TECHNICAL SERVICE BULLETIN

Vibration/Pulsation From Brakes - Brake Pad Material Stuck To Rotor - Built On Or Before 06-Jan-2022

22-2023

Ford 2021-2022 Mustang Mach-E	Built on or before 06-Jan-2022
----------------------------------	--------------------------------

Figure 2 - Original Front Brake Pad

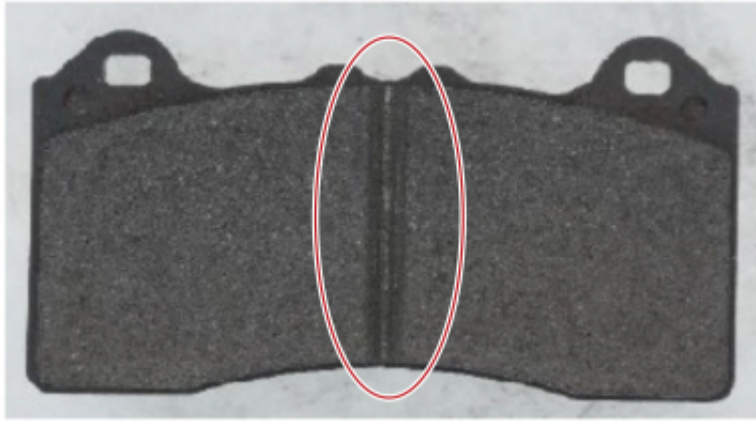
- (1). Yes - proceed to Step 2.
 - (2). No - proceed to Step 4.
2. Replace the front brake pads with the revised brake pads without the center V channel. Refer to Workshop Manual (WSM), Section 206-03. (Figures 2-3)

Figure 3 - Revised Brake Pad
